ADDENDUM NO. 1 TO BID FORMS

**CORONA-NORCO UNIFIED SCHOOL DISTRICT
PURCHASING DEPARTMENT
Bid No. 2023/24-204**

CORONA FUNDAMENTAL INTERMEDIATE SCHOOL MPR MODERNIZATION

SHEET NO.:
A-411

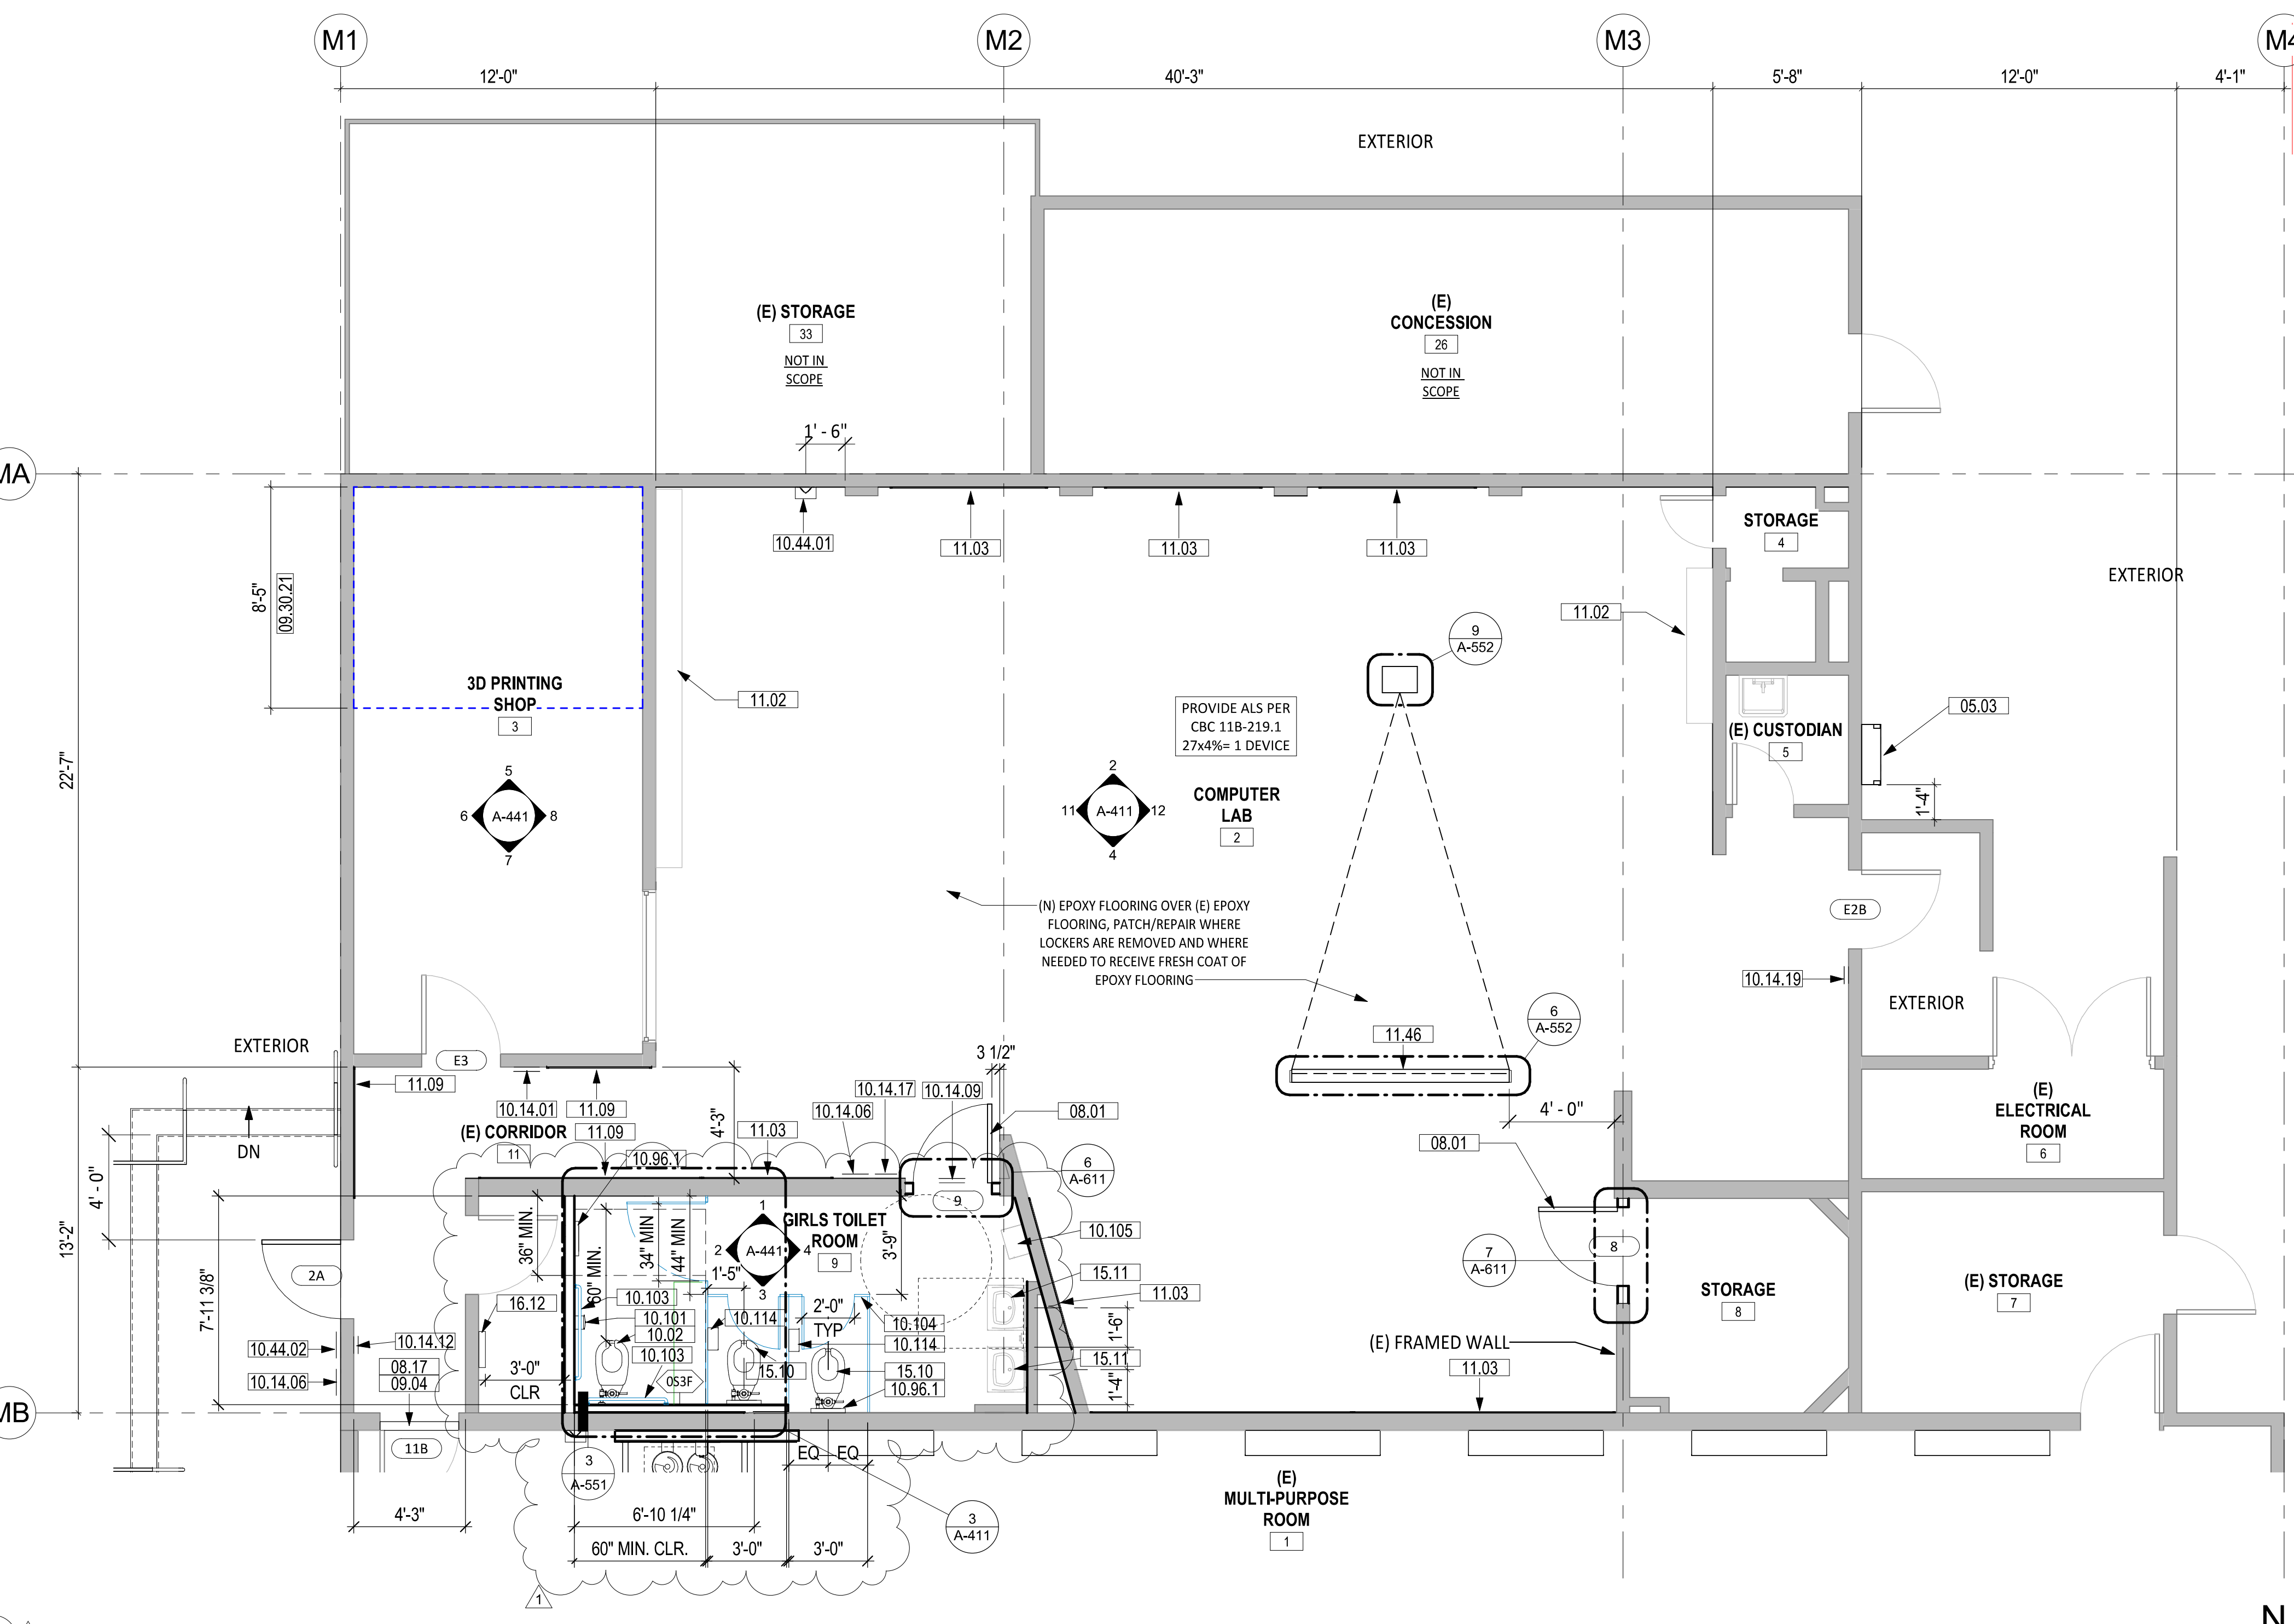
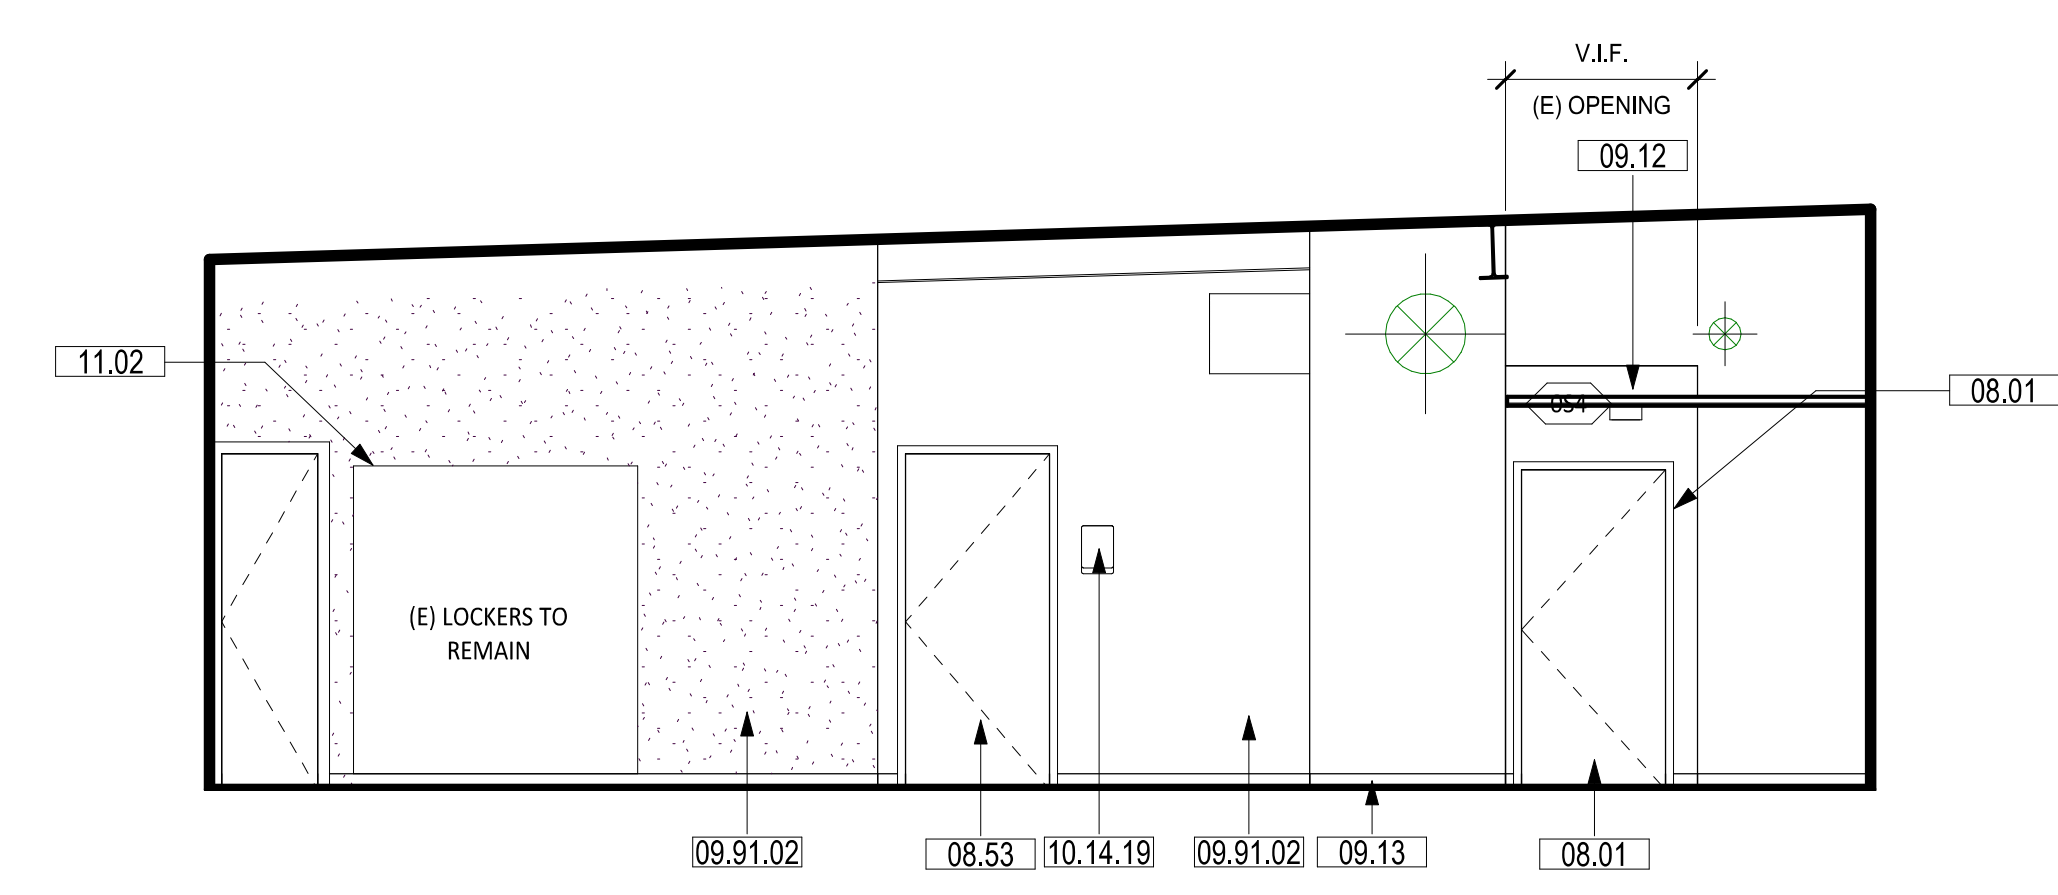
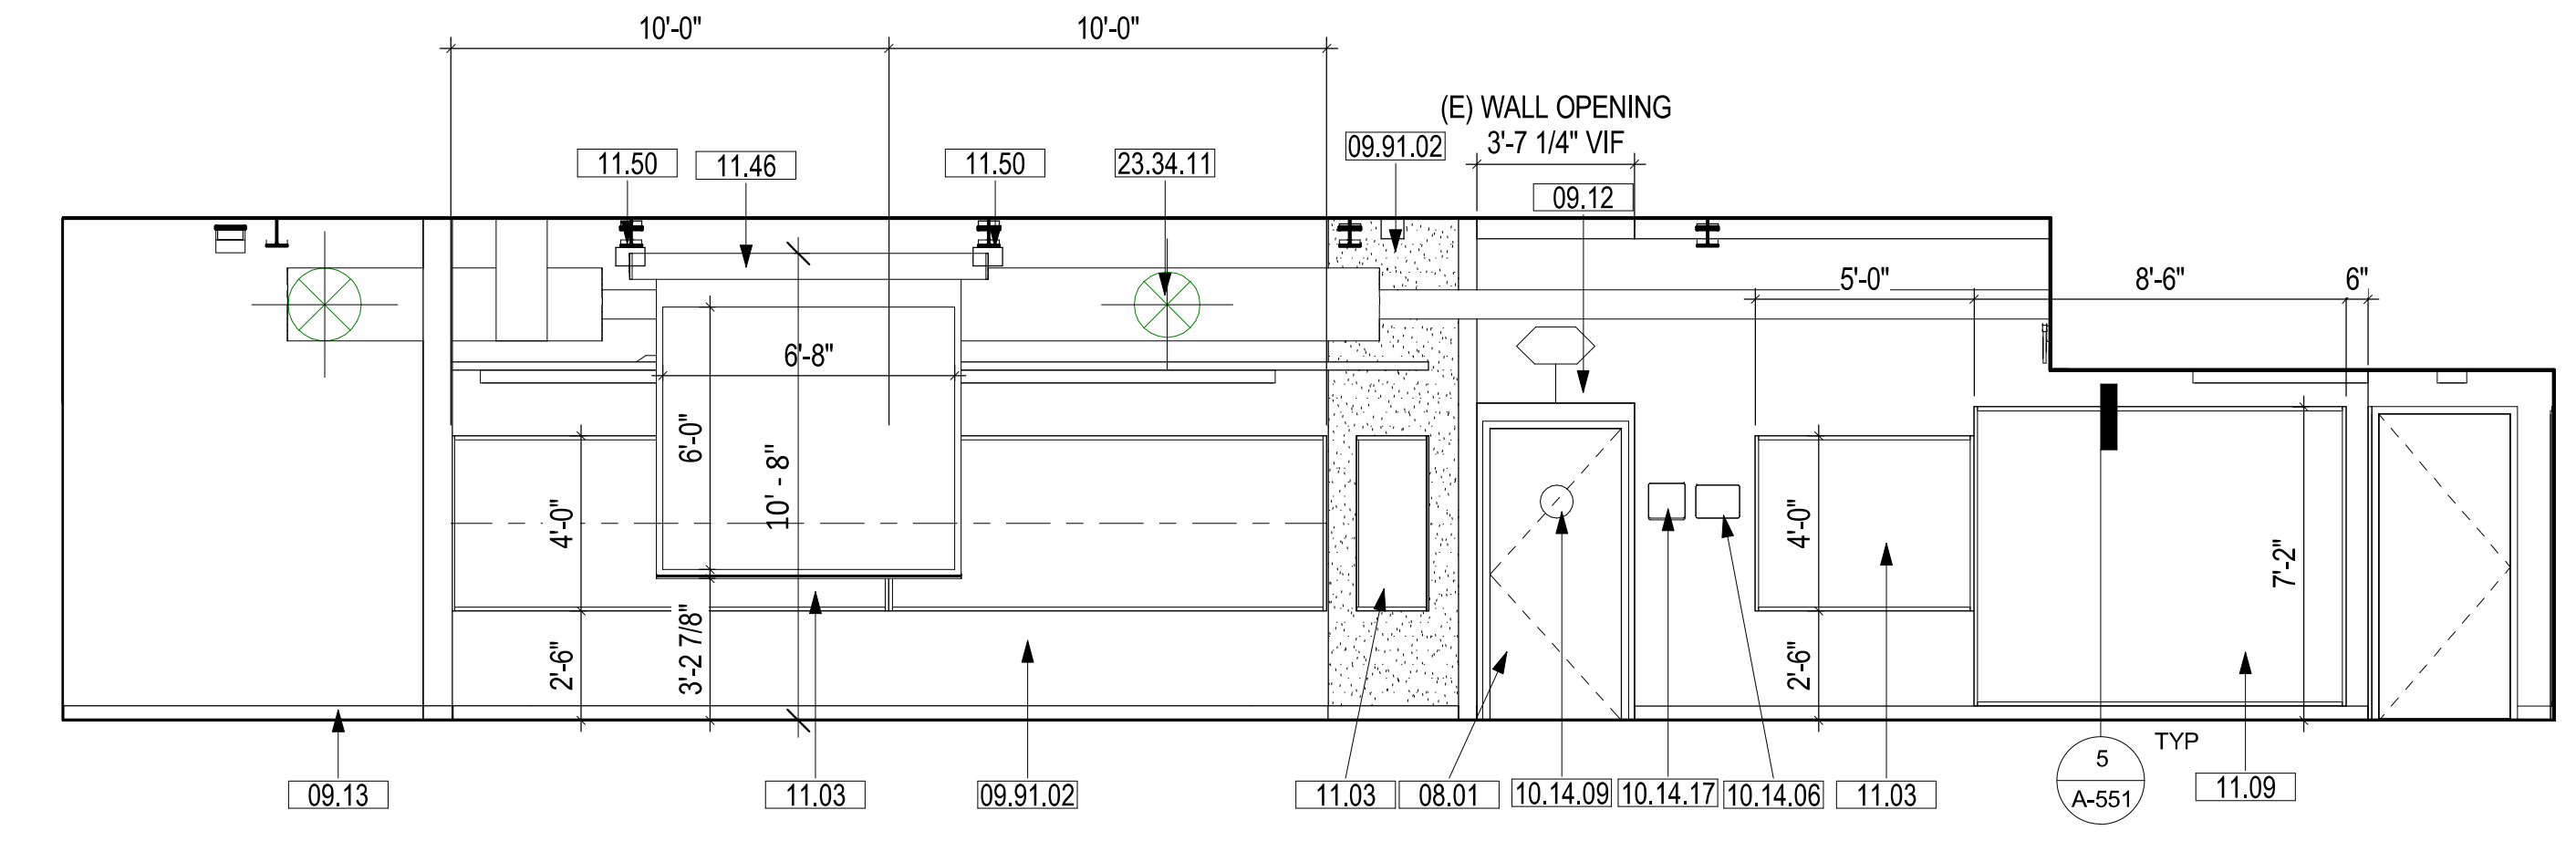
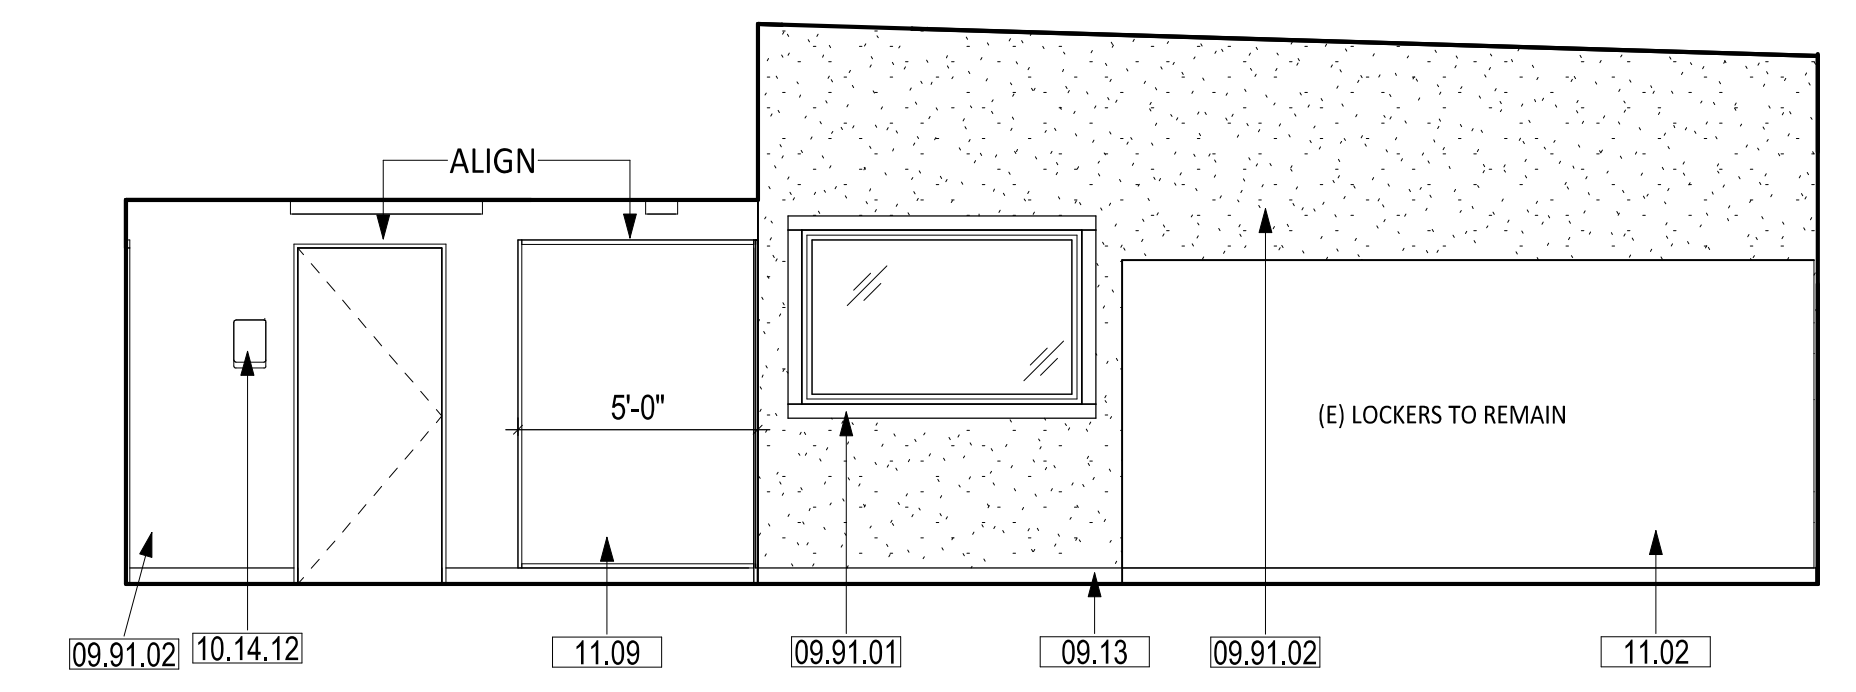
Item No. 1.05
Sheet A-411 - COMPUTER LAB ROOM 2 - ENLARGED PLAN & INTERIOR ELEVATIONS

- Girls' Toilet Room 9 layout revised
- Keynote 11.50 revised
